# NEWMAR CORPORATION

# TECHNICAL SERVICE BULLETIN

DATE ISSUED	MODEL YEAR(S) AFFECTED	TSB #
10/19/2017	2018	497

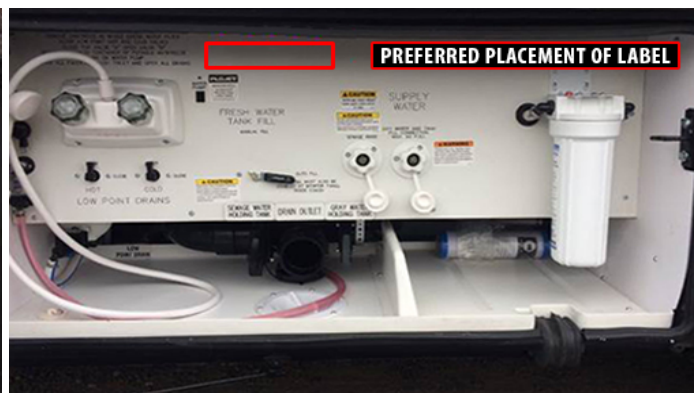
Newmar has determined that certain 2018 Dutch Star and Ventana coaches were shipped without a notice label regarding the ShowerMiser.

Issue: The customer or servicing technician may not place the ShowerMiser valve in the correct position when pumping antifreeze into the water lines during the winterization process. This may allow antifreeze to be pumped into the fresh water tank.

Order the notice label (part # 139030) from the Newmar Parts Department. Once you have label, wipe the water works panel clean. Place the label and adhere it above, below, or beside the winterizing text on the water works panel. Below are some examples:
